# BRAKING IO

## POD 5

Title <b>Braking IO PCB</b>		Badgerloop Electrical 133 Engineering Research Building 1500 Engineering Drive Madison, Wi 53706	
Engineer:	Revision:

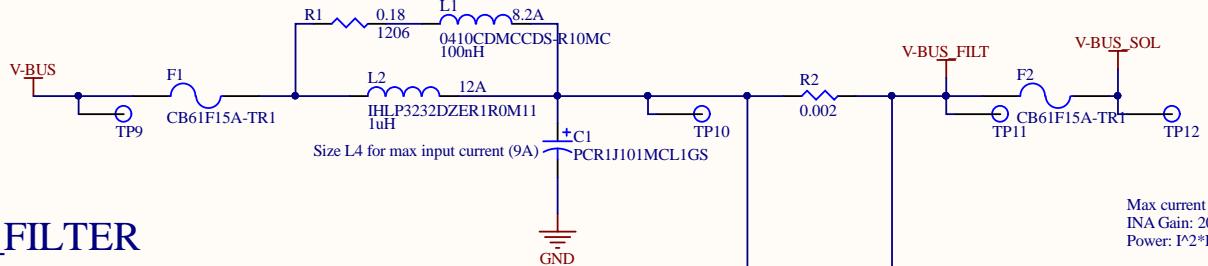
should change upstream fuse to be higher current rating than downstream.

#### Title *Connectors*

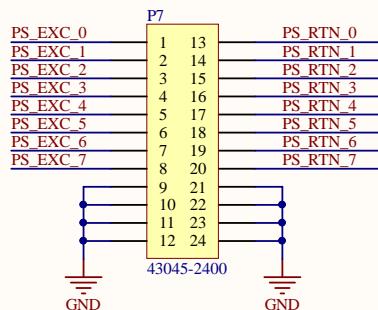
Split into 2 connectors as only 4 solenoids are likely to be used
